# PARKER AND PINE FILING NO. 1 LOT 2 – SITE PLAN

MURPHY OIL USA, INC.

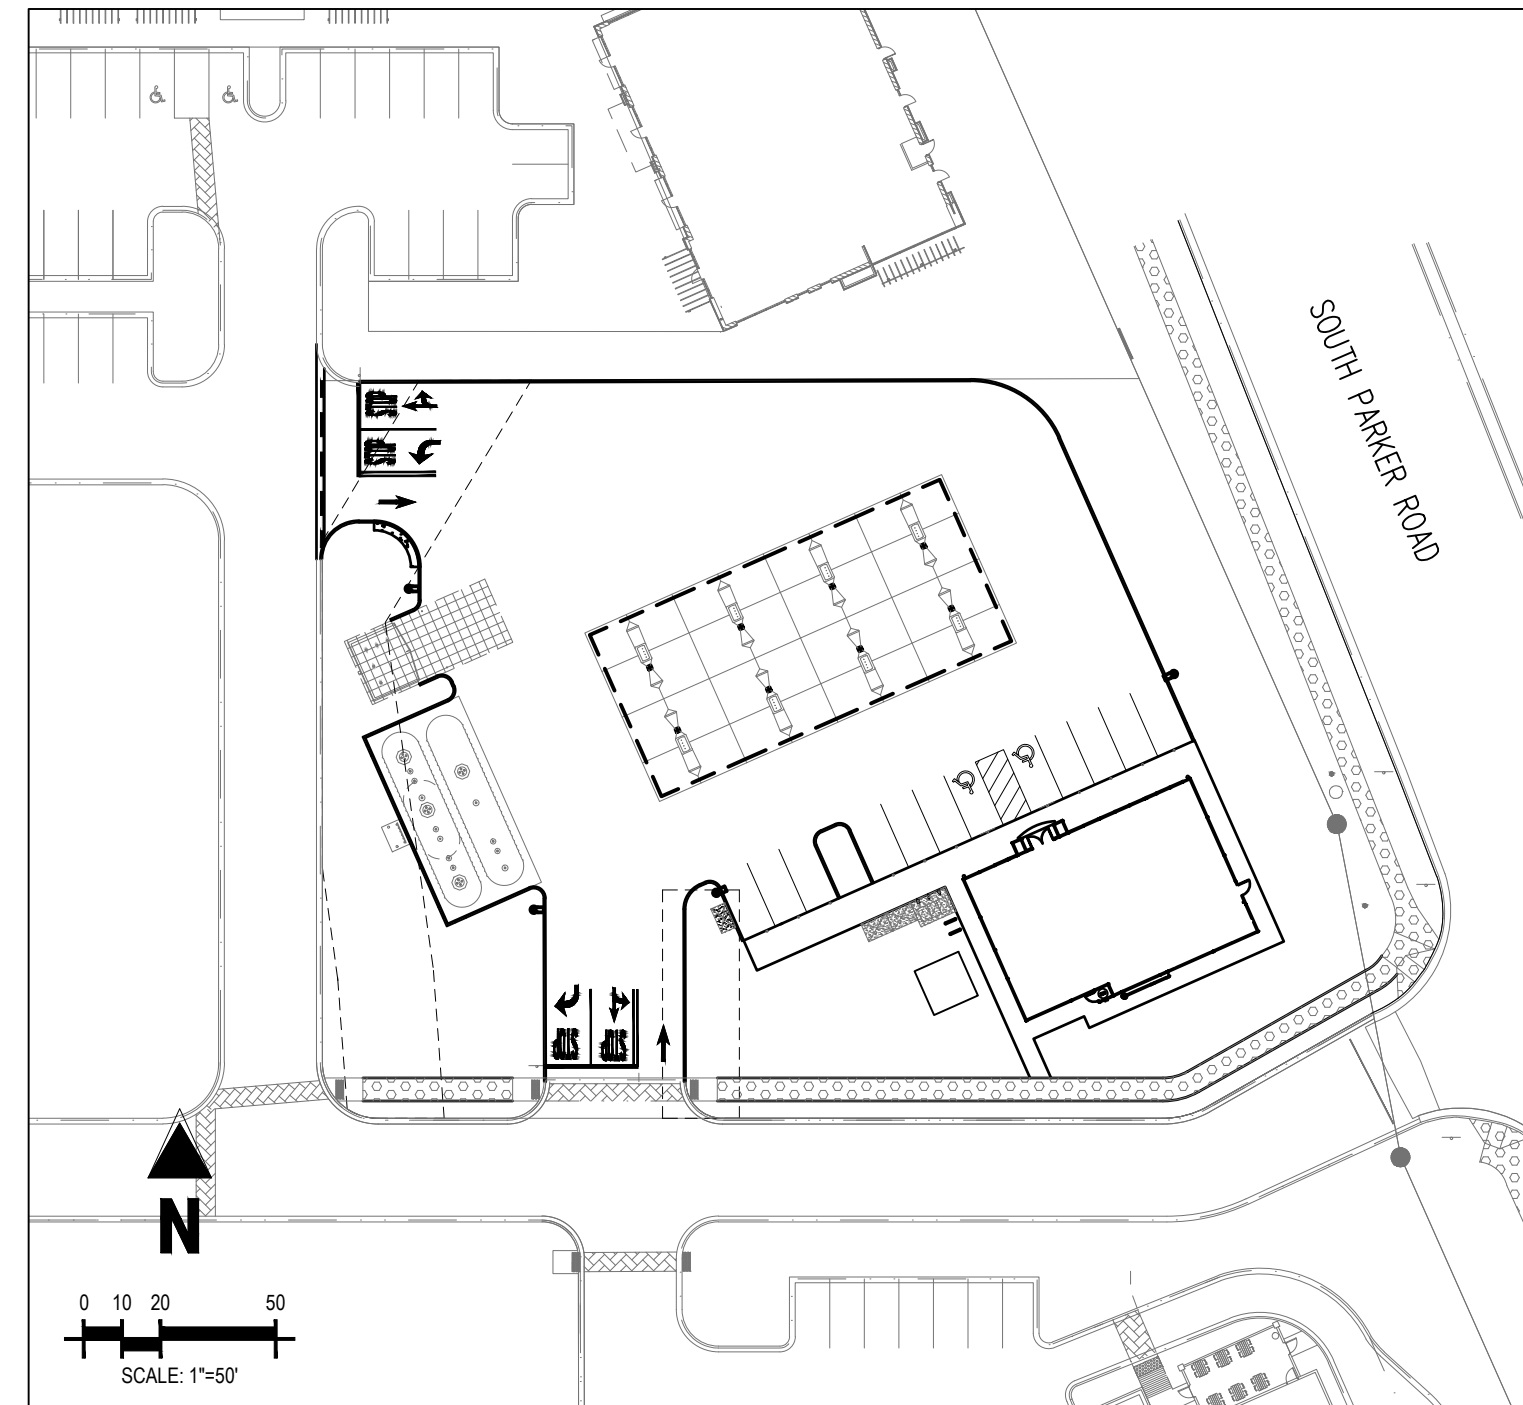
**SIGNAGE NOTE:** APPROVAL OF A SIGN PERMIT IS REQUIRED IN ADDITION TO DEVELOPMENT PLAN APPROVAL. SIGN LOCATIONS SHOWN ON THE DEVELOPMENT PLAN WILL BE REVIEWED FOR POSSIBLE CONFLICTS WITH SIGN TRIANGLES AND EASMENTS. THESE SIGNS WILL NOT BE APPROVED BY THE DEVELOPMENT PLAN REVIEW PROCESS. ALL SIGNS MUST CONFORM TO THE CITY'S STANDARDS.
